Re: Osbaldo Perez
8737 Central Ave. NW
Traffic Circulation Layout
Architect's Stamp 06-22-23 (K09-D053)

Based upon the information provided in your submittal received 12-22-23, the above referenced plan cannot be approved for Building Permit until the following comments are addressed:

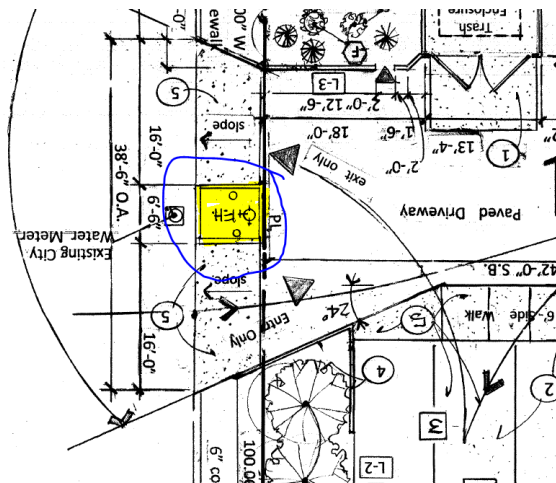
1. Please show a vicinity map showing the location of the development in relation to streets and well known landmarks.
2. List the number of parking spaces required by the IDO as well as the proposed number of parking spaces including bicycle and motorcycle parking.
3. Identify all existing access easements and rights of way width dimensions.
4. Sidewalk per City std 2430 must be developed from property line to property line off Frontage Rd. for sidewalk waiver, please contact Ernest Armijo at (505)924-3991 or earmijo@cabq.gov.
5. Please provide site access design details.
6. If the site access is one-way only please provide the following: All one-way drives shall have "One Way" and "Do Not Enter" signage and pavement markings. Please show detail and location of posted signs and striping.
7. Please clarify, what is this?

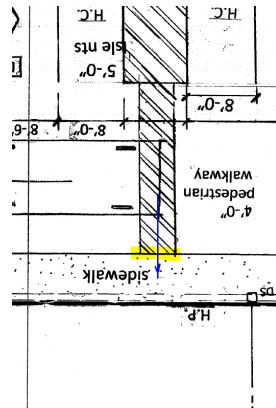
16. A 1-foot clear zone around the bicycle parking stall shall be provided.
17. Bicycle parking spaces shall be at least 6 feet long and 2 feet wide.
18. A 5 ft. keyway is required for dead-end parking aisles.

19. Per the IDO, a 6 ft. wide ADA accessible pedestrian pathway is required from the public sidewalk to the building entrances. Please clearly show this pathway and provide details.

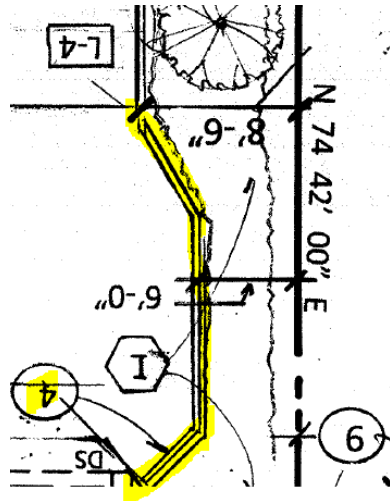
20. Per DPM, a 6 ft. wide ADA accessible pedestrian pathway is required from the ADA parking stall access aisles to the building entrances. Please clearly show this pathway and provide details.
21. Please define this ADA pathway by labeling of ramps, flush and show on the site plan the main building entrance.

22. A 5 ft. keyway is required for dead-end parking aisles.
23. Please clarify, is the keynote 4 refers to curb?
